**Subject: Committee Request for Additional Information  
Polk Street Maintenance  
Chatham County, Georgia**

**RLC# 08-028**

## TECHNICAL MEMORANDUM NO. 21-002

**SUBJECT:** Update to 2014 hydrological and ecological assessment of proposed Polk Street maintenance project, City of Tybee Island, Georgia.

SHEET NAME:  
BRIDGE OPTION #1  
CLIENT:  
RESOURCE + LAND CONSULTANTS  
LOCATION: TYBEE ISLAND, GA  
DATE: 02/19/2021  
JOB NUMBER: J-29077  
DRAWN BY: KHT  
REVIEWED BY: JVG  
SHEET: EX2  
SCALE: 1" = 100'

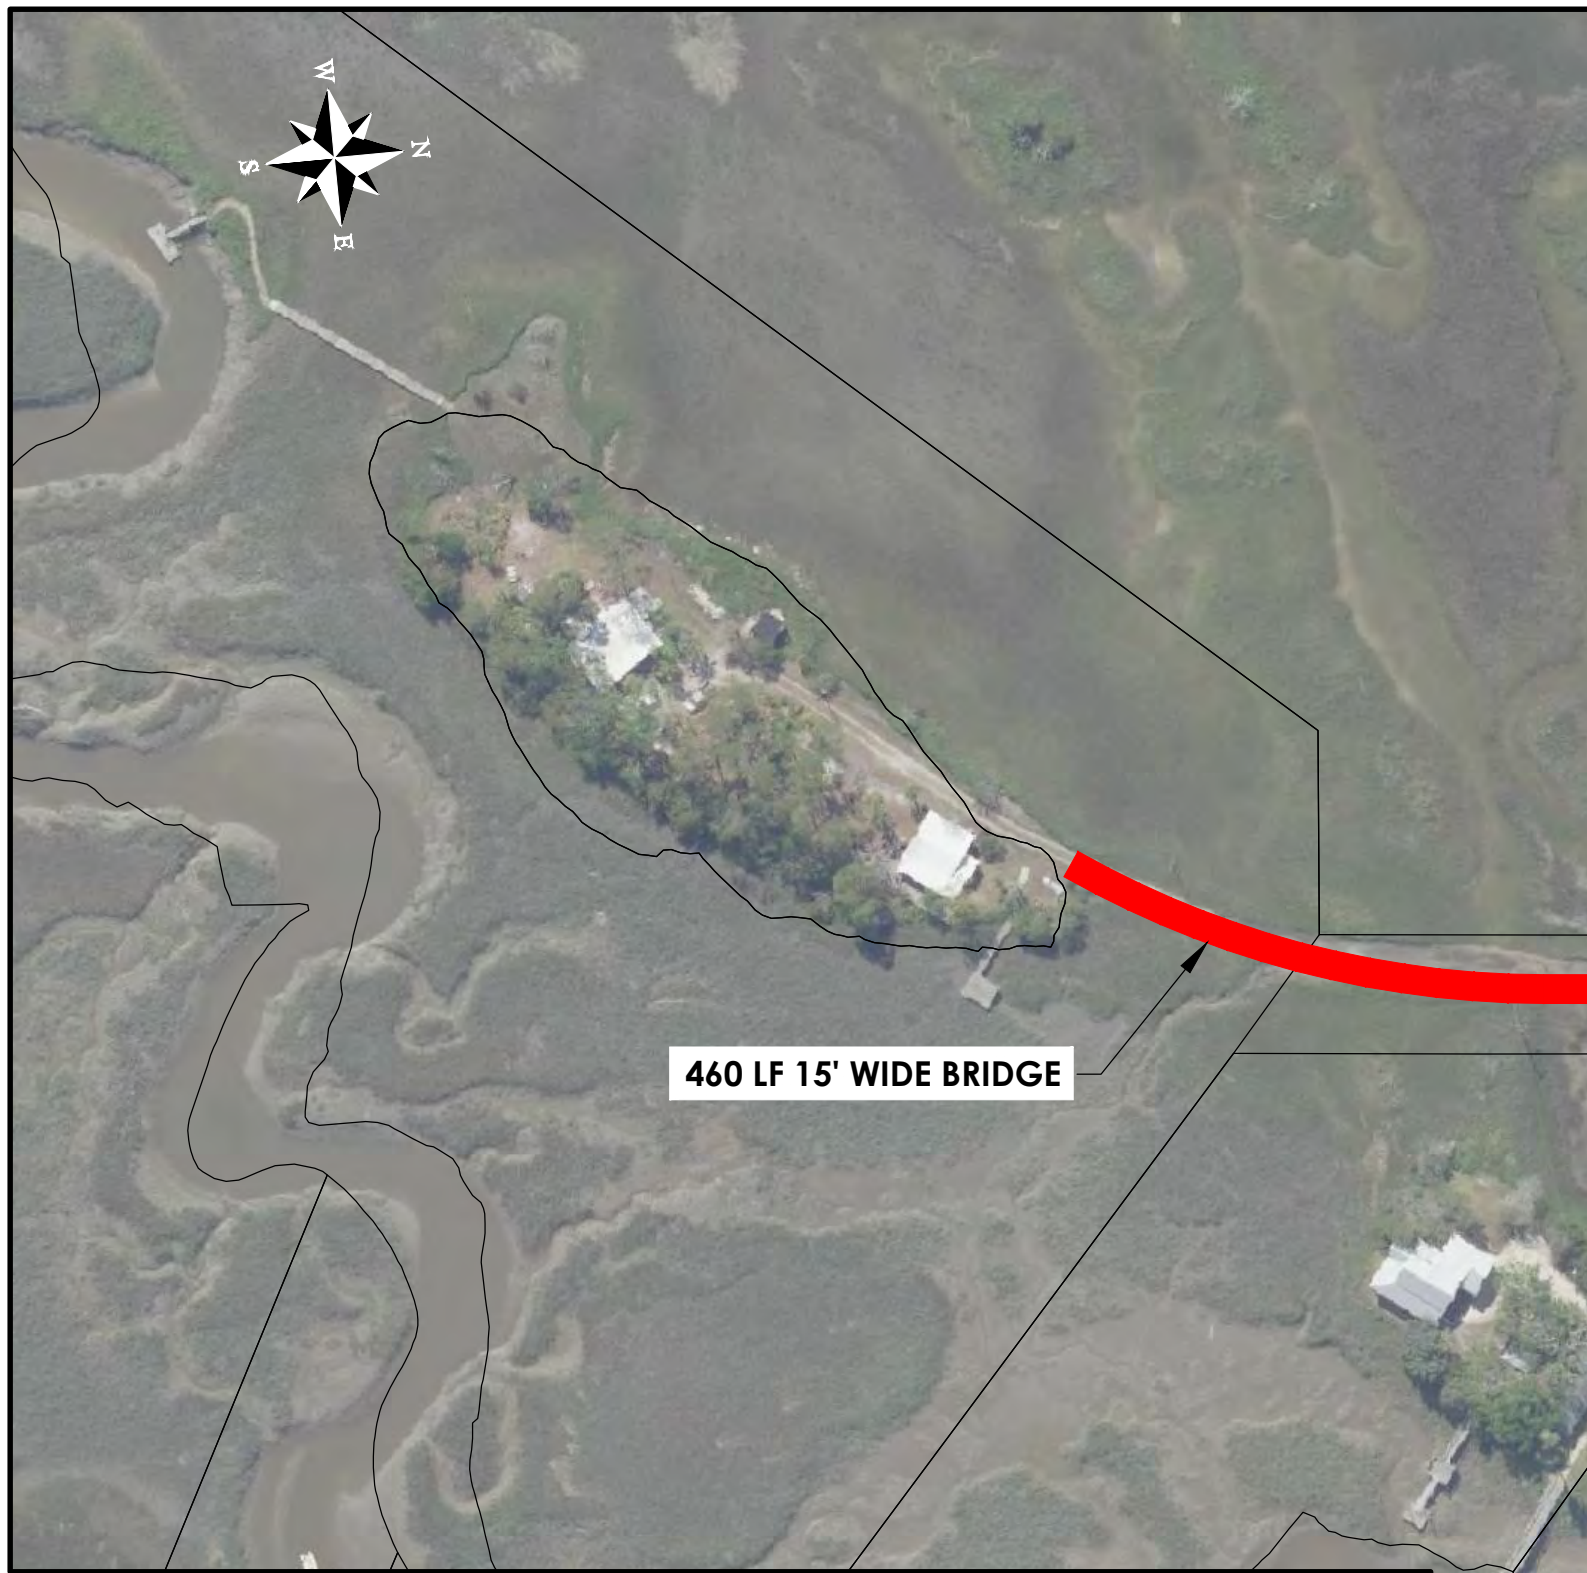
7. *Provide analysis of wooden bridge for all or portions of the project:* Thomas & Hutton was retained to complete a cost assessment for maintenance design alternatives including road fill, concrete bridge and wooden bridge. As documented in the attached exhibits the estimated project costs are as follows:

<b>Maintenance Design</b>	<b>Estimated Unit Cost</b>	<b>Estimated Cost</b>
Road Fill (460 lf)	\$3.40/sf	\$32,769.00
Concrete Bridge (460 lf)	\$250/sf	\$1,725,000.00
Timber Bridge (460 lf)	\$215/sf	\$1,483,500.00
Concrete Bridge (three sections/319 lf)	\$325/sf	\$1,555,125.00
Timber Bridge (three sections/319 lf)	\$275/sf	\$1,315,875.00
